### **REMARKS**

This Amendment is responsive to the Office Action of November 25, 2002. Reconsideration of the rejections of Claims 1-10 and 12-17 is respectfully requested. By this Amendment Claims 1, 7, 8 and 13 have been amended. Claim 11 has been cancelled. New Claims 17-24 have been added and consideration of these new claims is requested.. The amendments and new claims do not add new matter. Allowance of the claims of this application is requested.

### **Drawing Amendments**

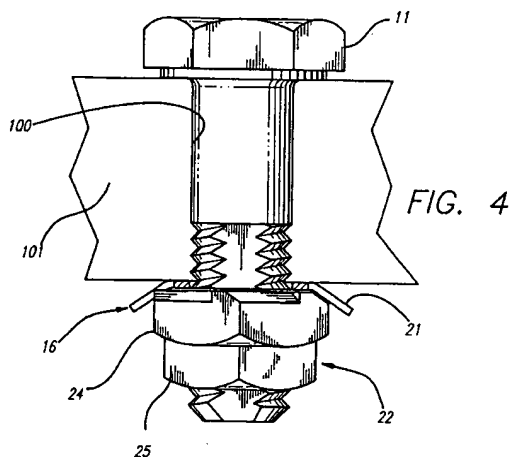
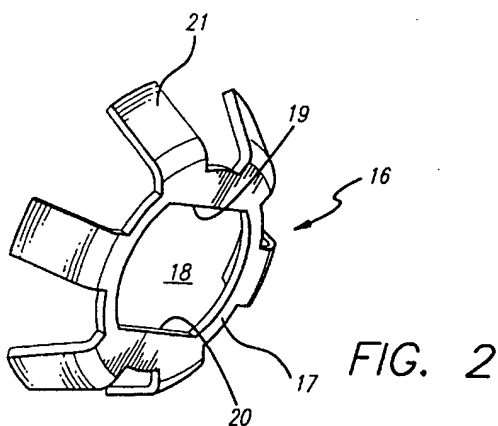
original specification, namely Figures 1, 3 and 4. Duran discloses a nut and bolt locking system with a washer 16 having a main body portion 17 and a number of spaced ears 21 (see Figures 2 and 4 from Duran reproduced below). The ears 21 are angled with respect to the main body portion 17, but are not generally perpendicular to the main body portion 17. In combination, the main body portion 17 and ears 21 do not have a cup shaped configuration, particularly when the washer is in place against the nut. Additionally, the washer of Duran would not function if having a cup shaped configuration. Ears 21 which would be generally perpendicular to the main body portion 17 would not properly engage with the angled flats on the face of the nut. Thus the disclosure of Duran does not anticipate Applicant's Claims 1 or 8 and reconsideration is required.
